Proposed Project Modifications

V25 and V26

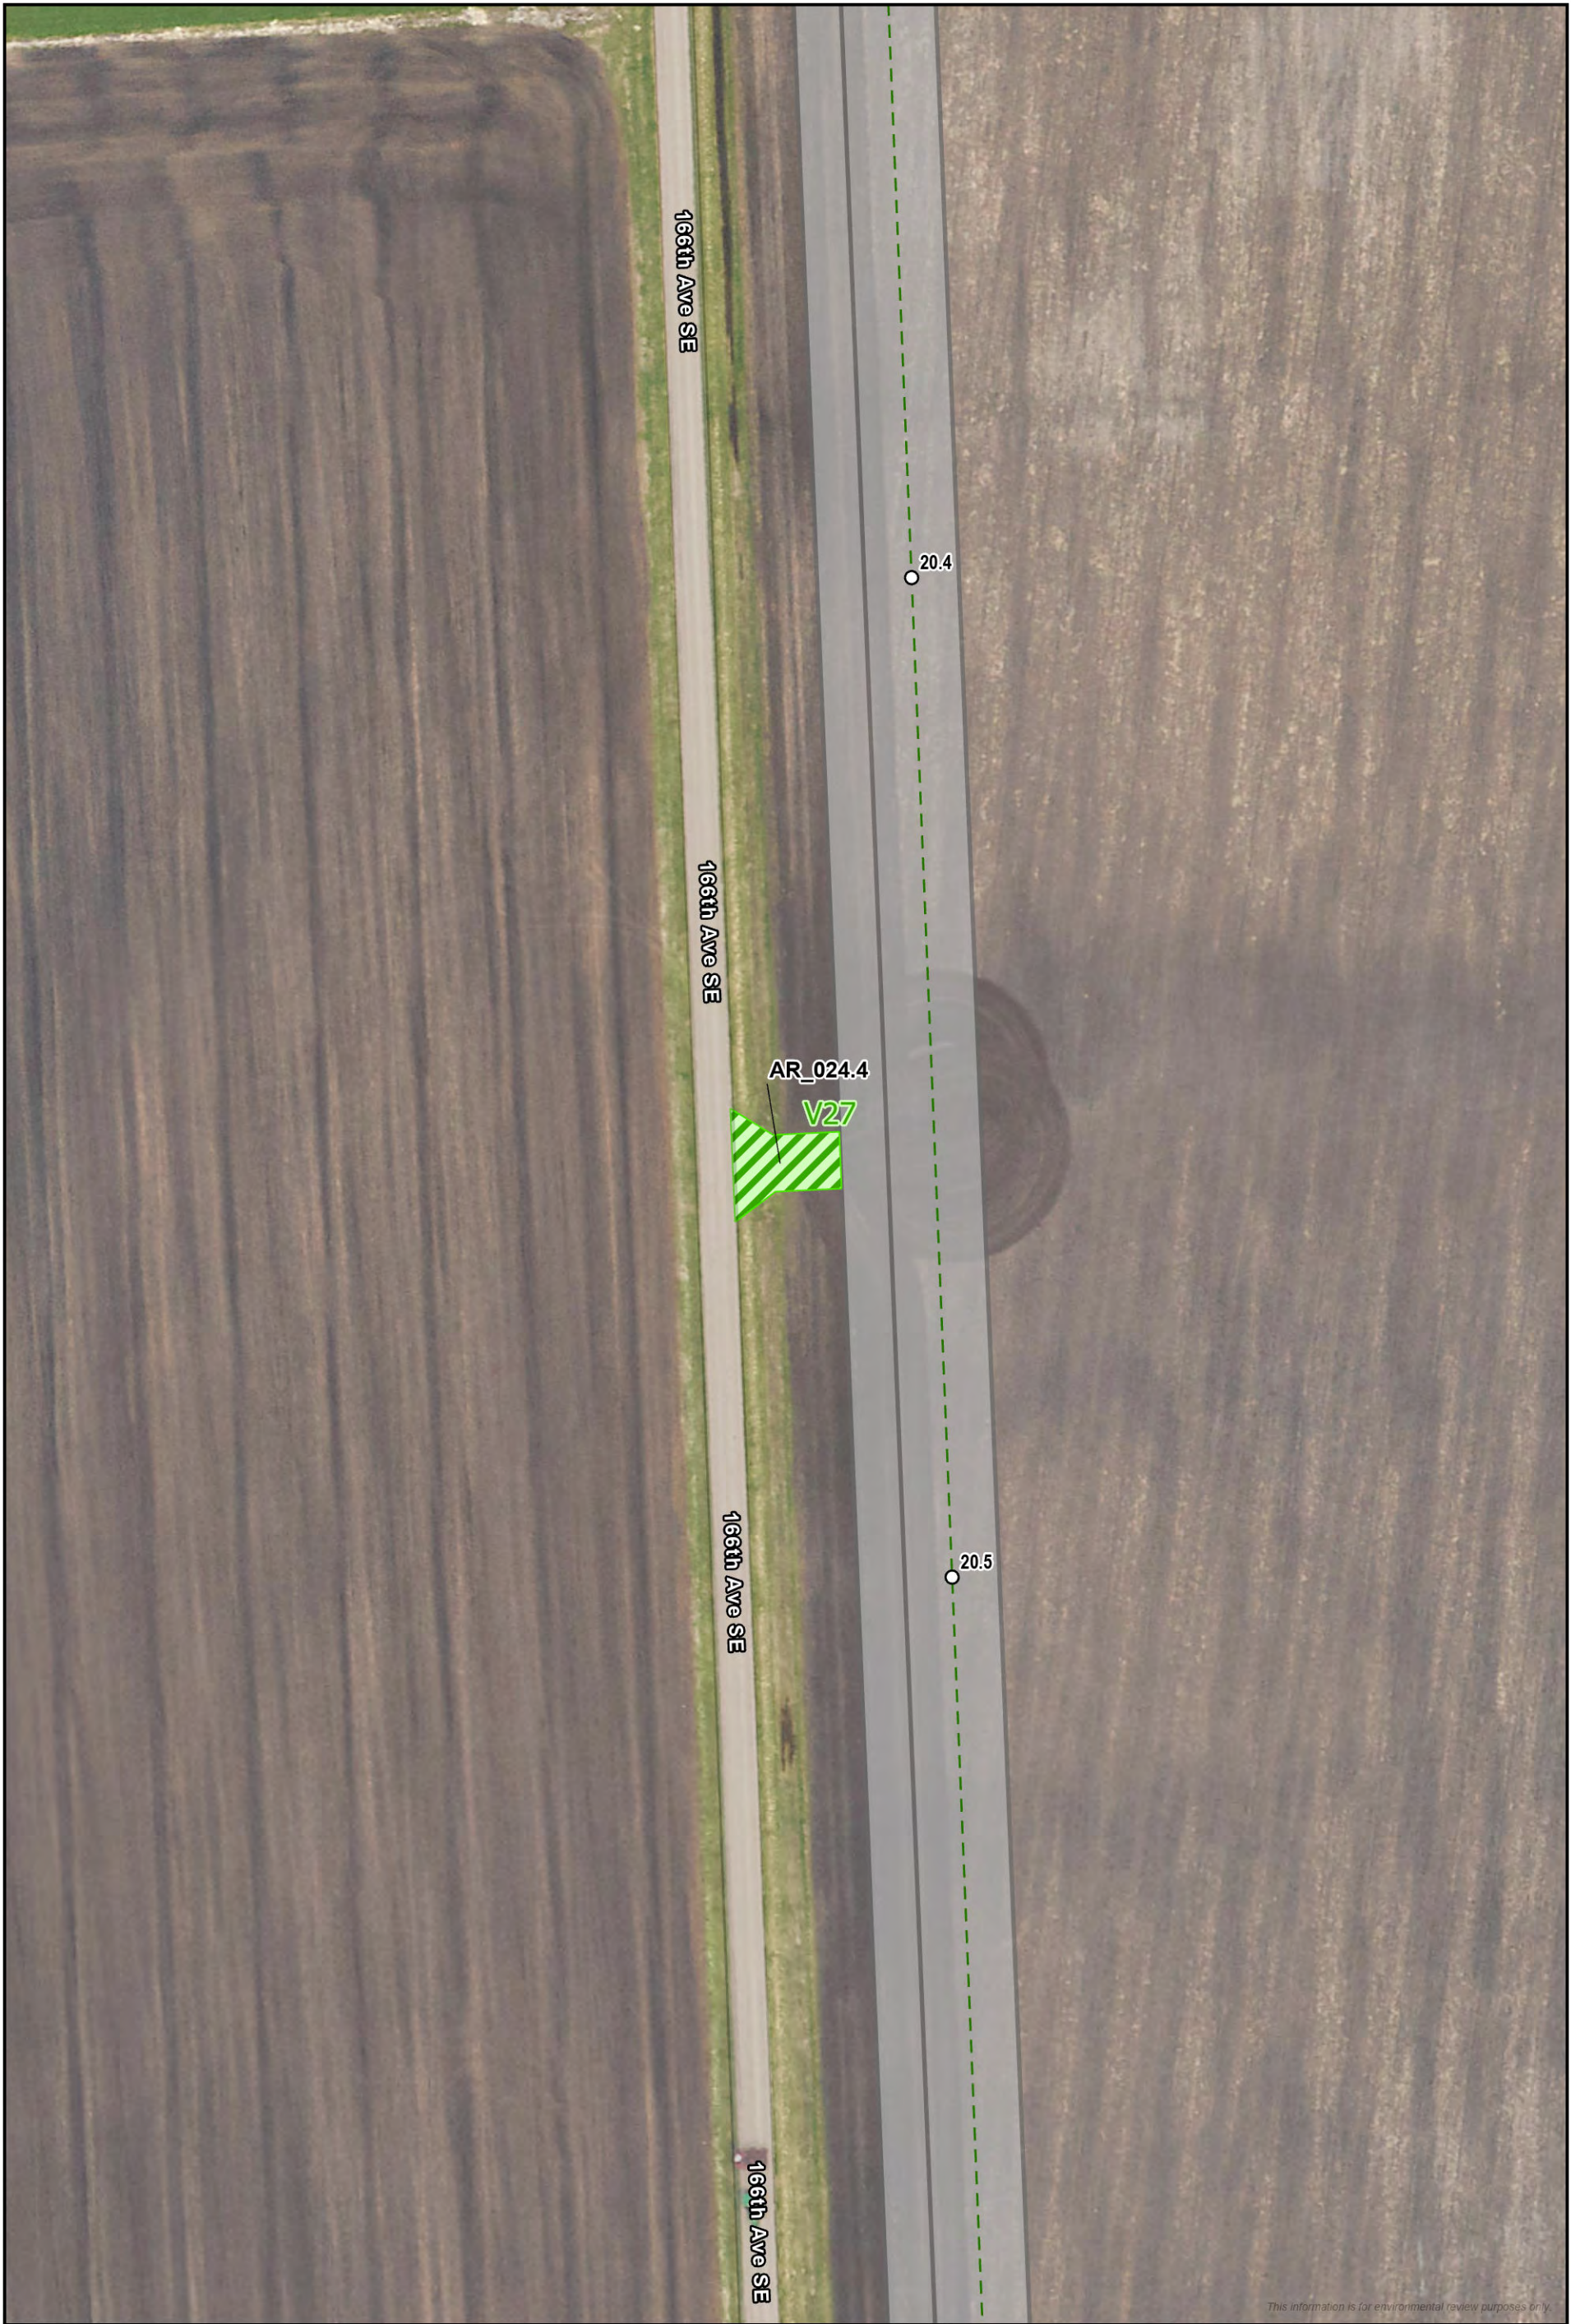
- Milepost
- Proposed Centerline
- ▨ TEMP Workspace Added
- No Change
- Surveyed Wetland
- Surveyed Waterbody

V27

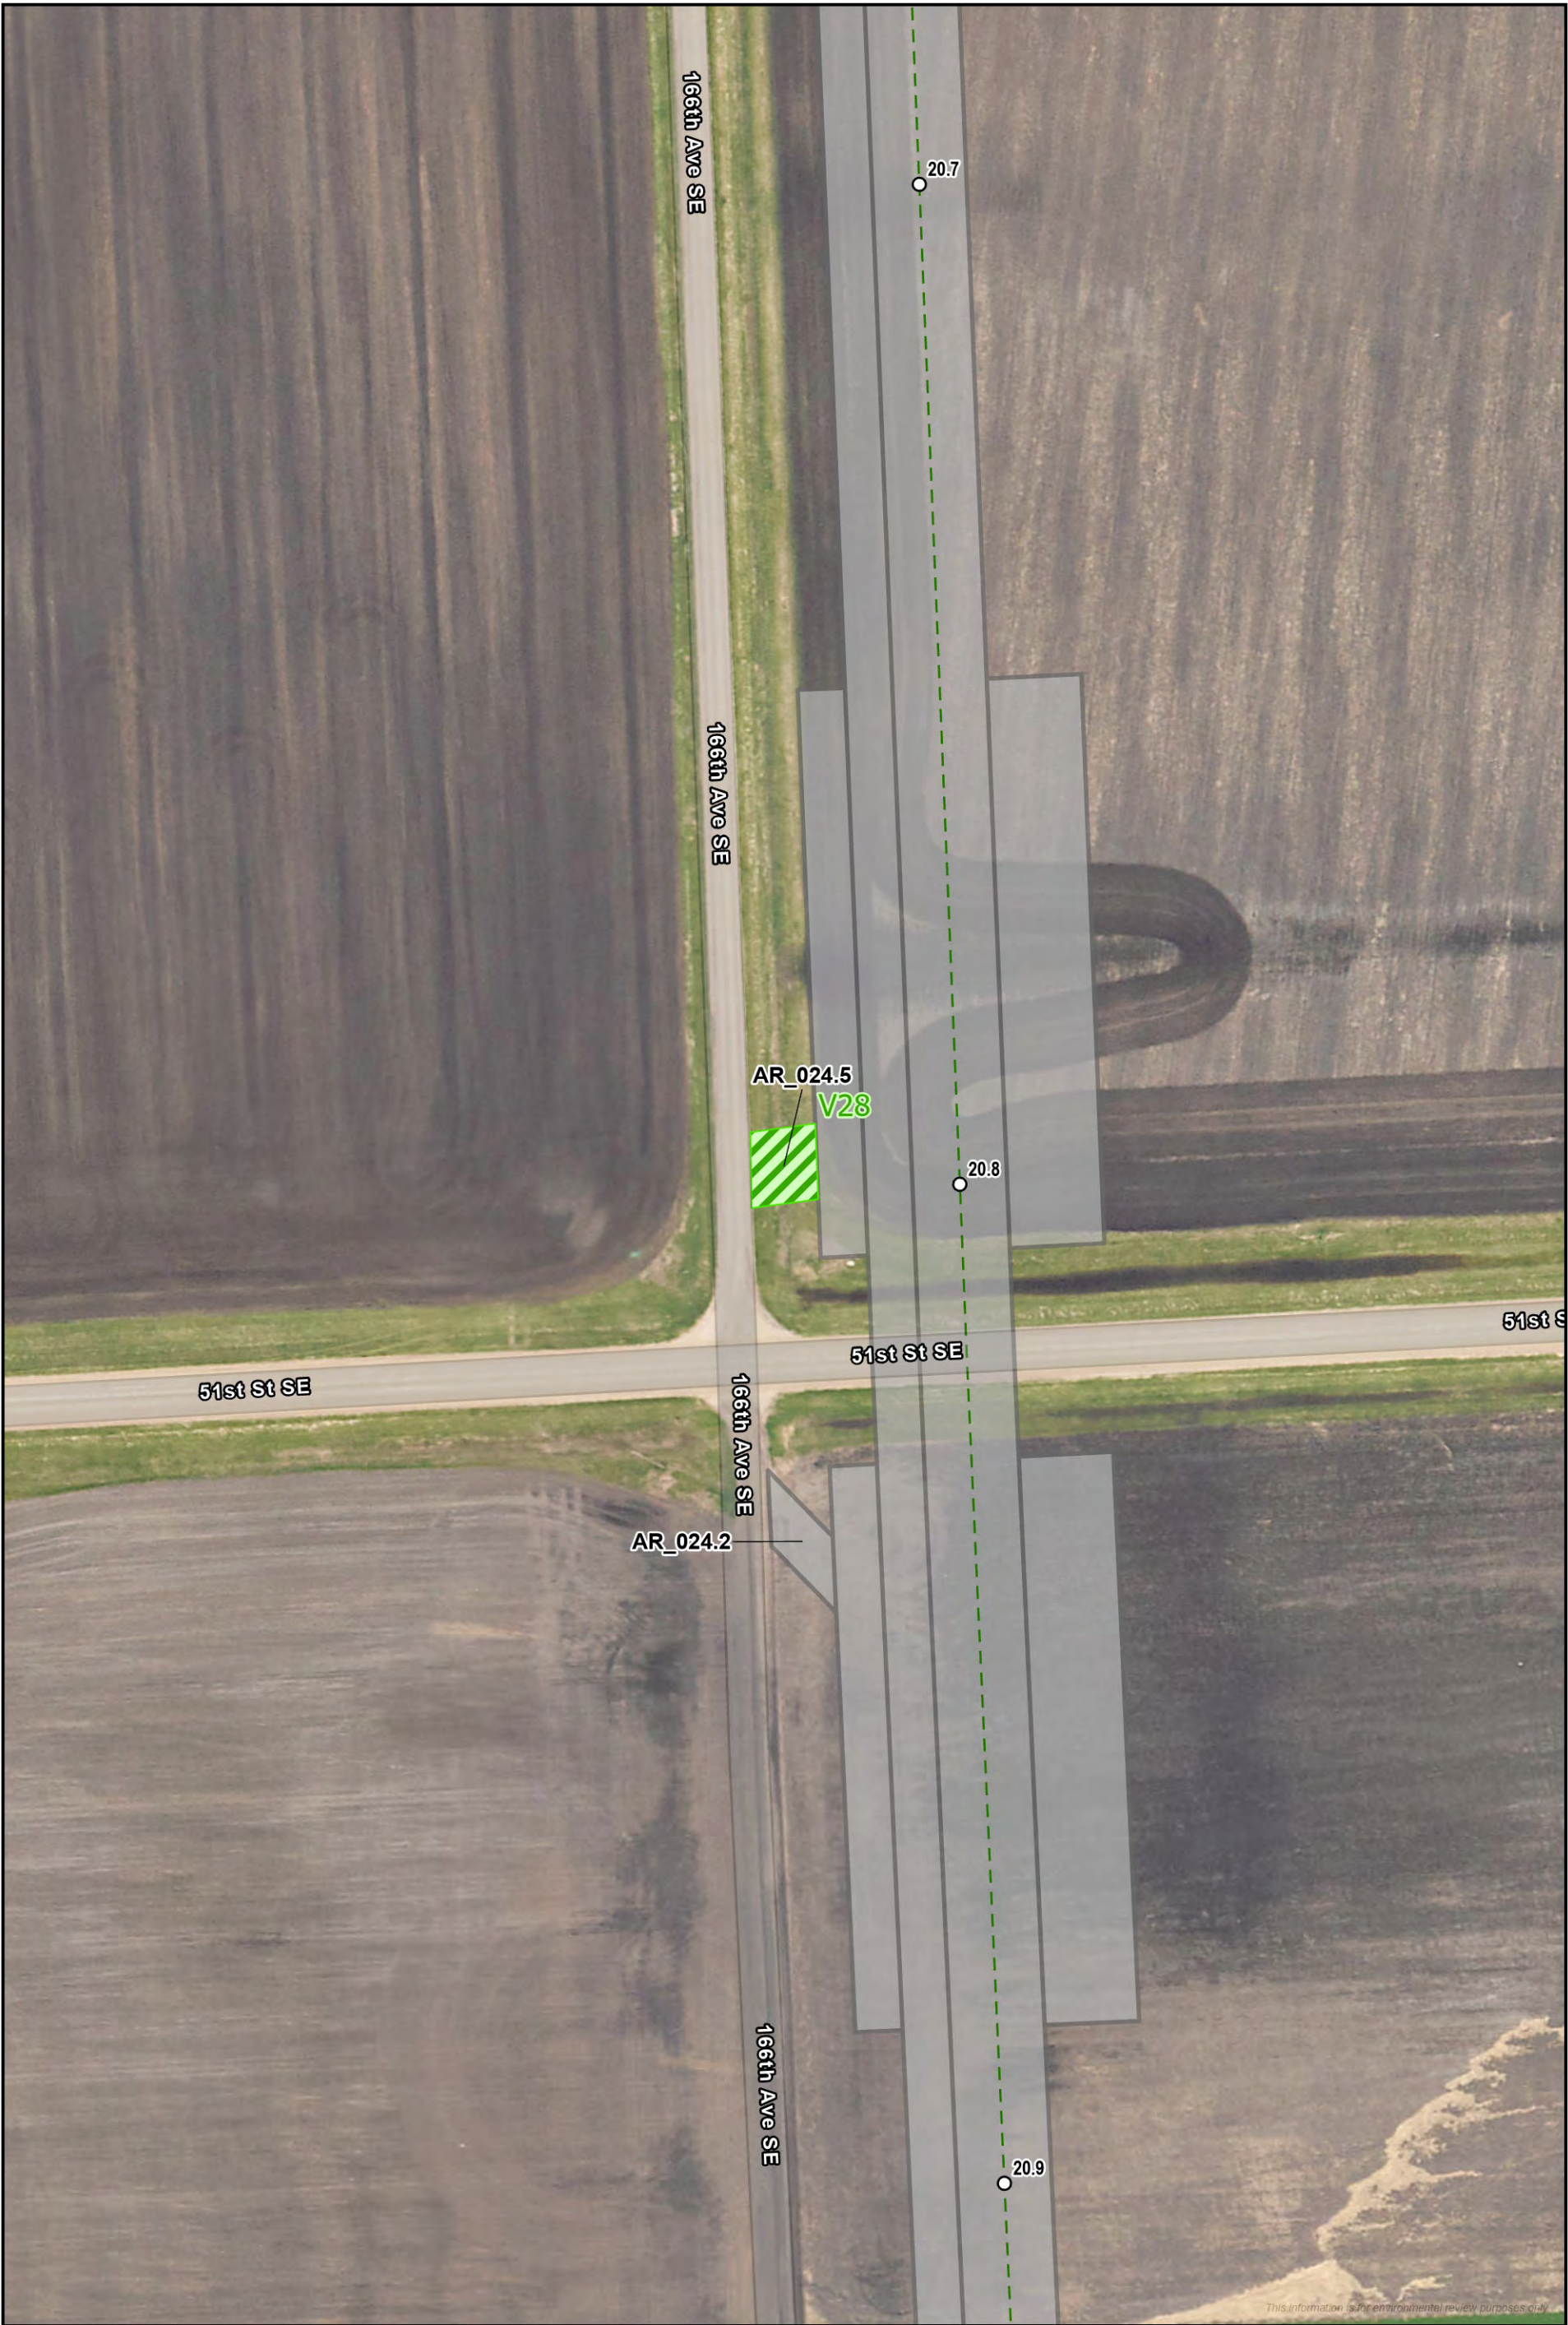
- Milepost
- Proposed Centerline
- TEMP Workspace Added
- No Change

V29

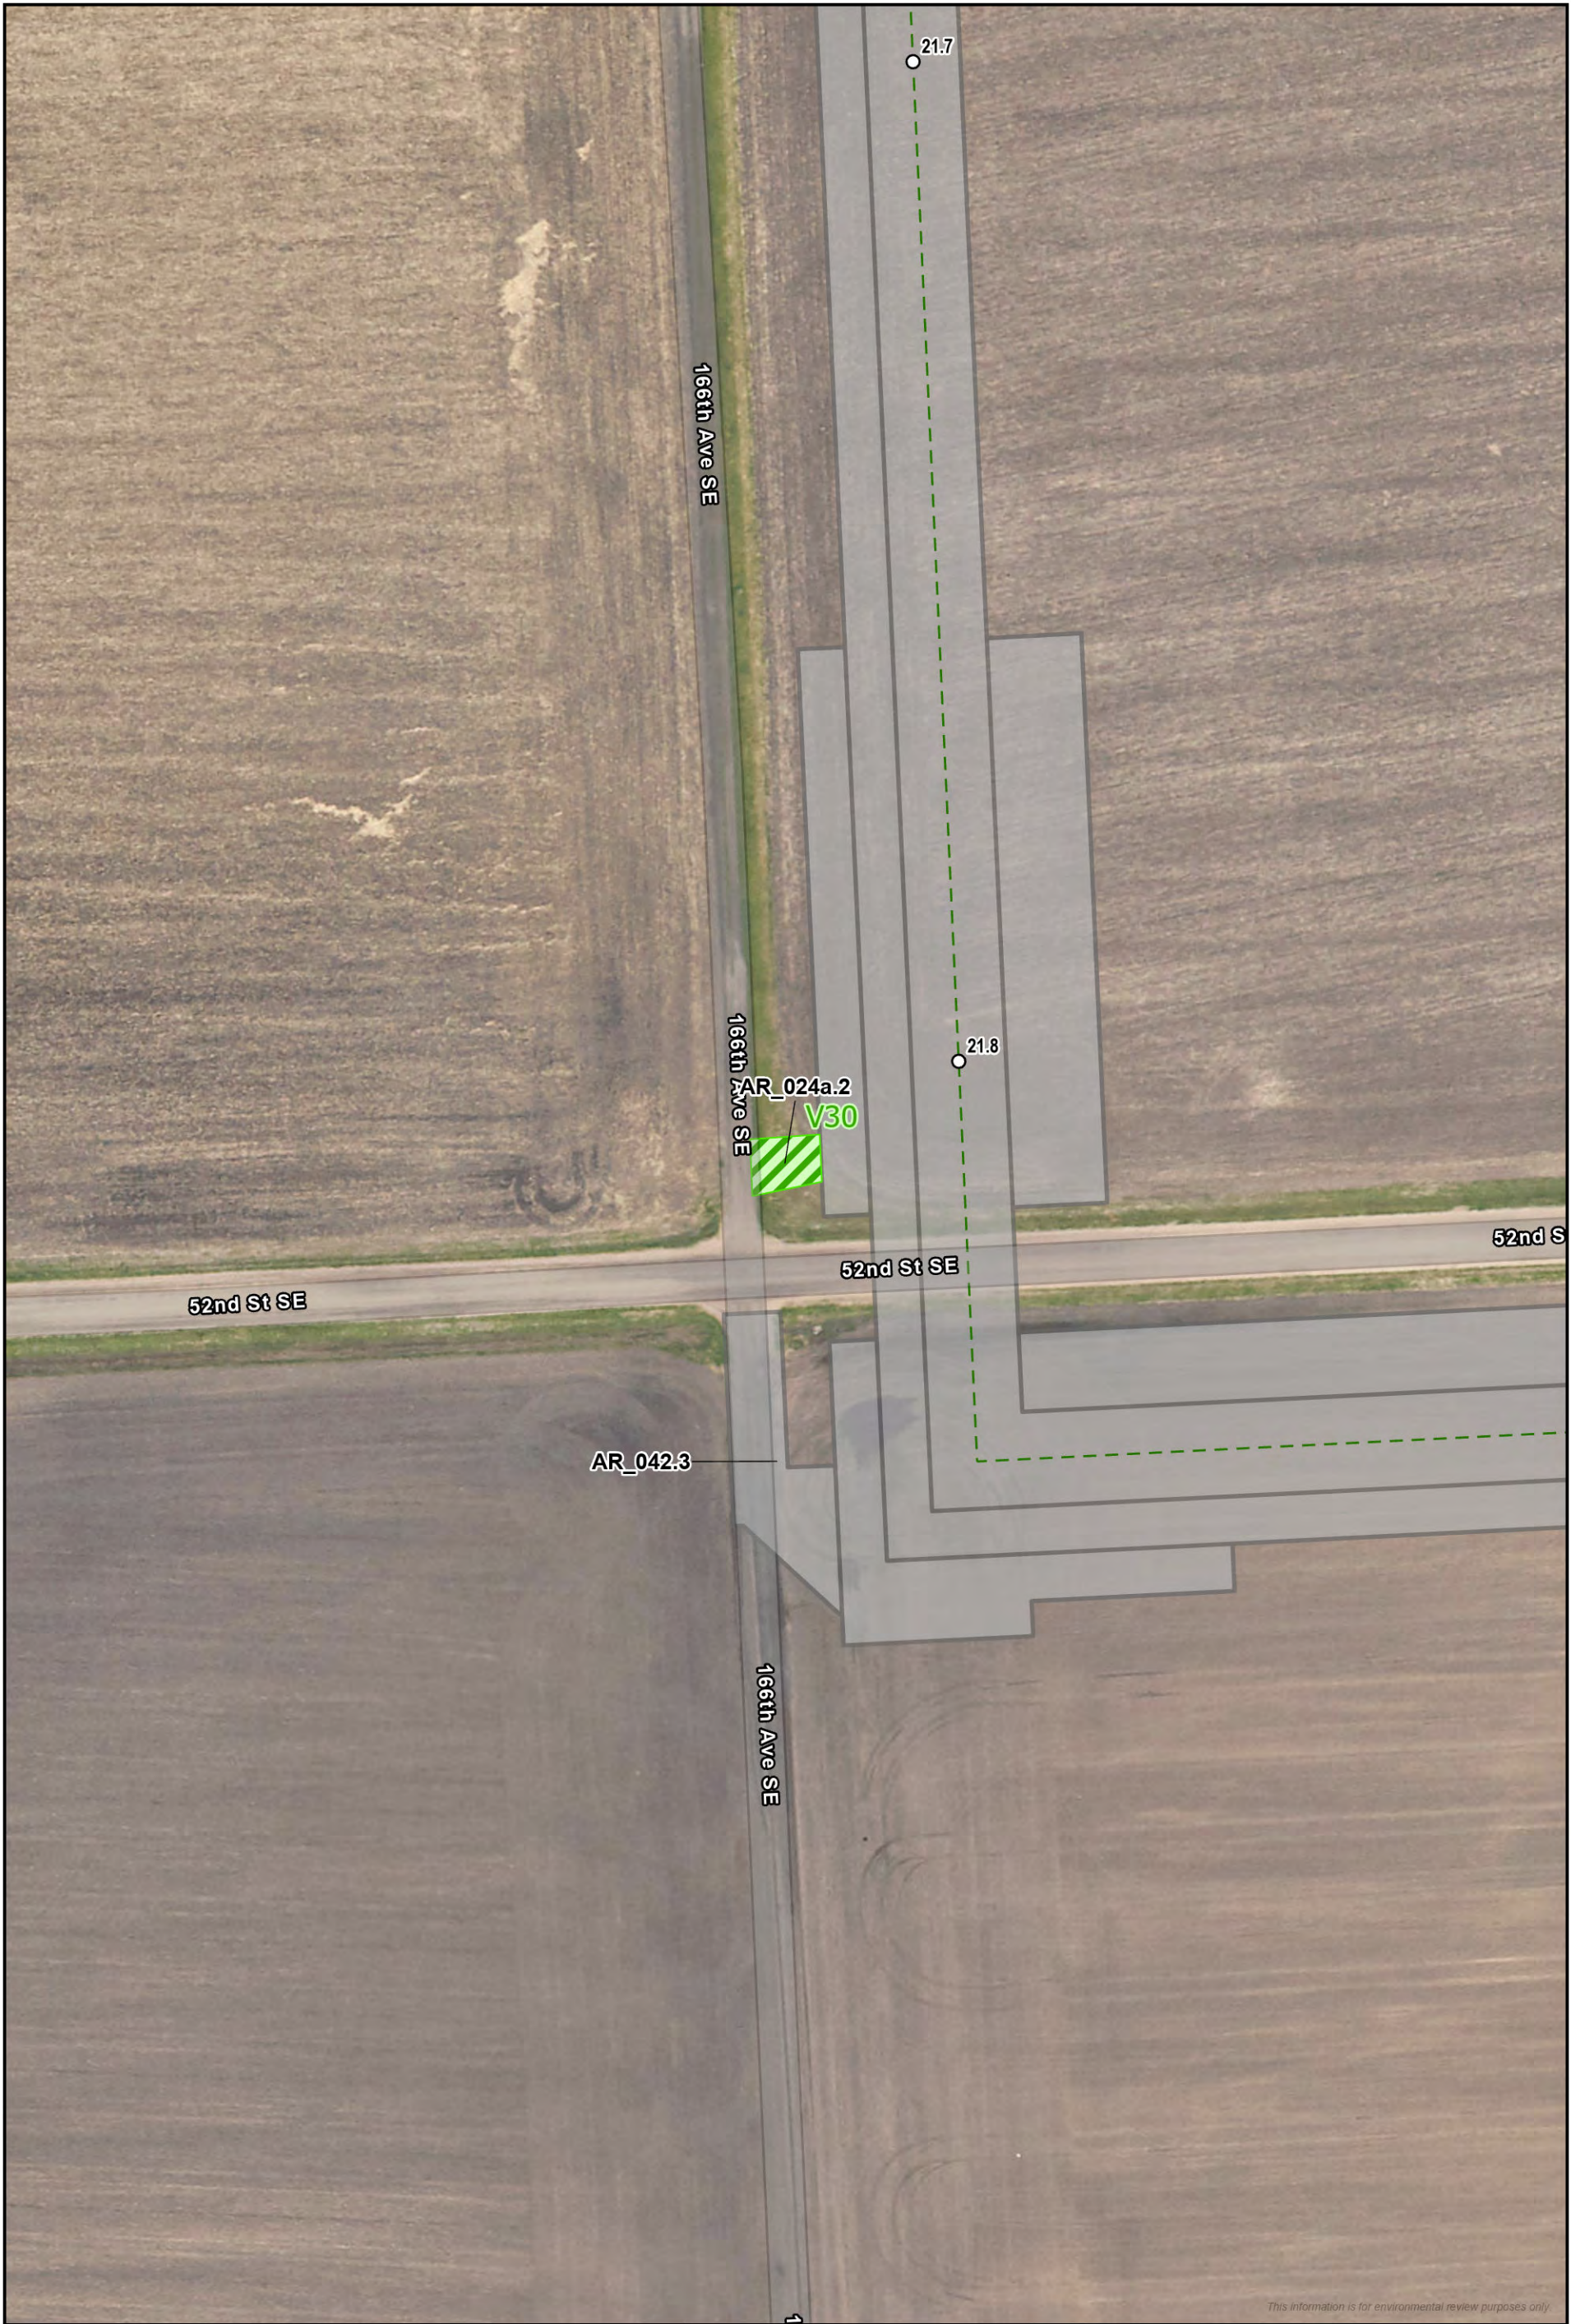
- Milepost
- Proposed Centerline
- TEMP Workspace Added
- No Change
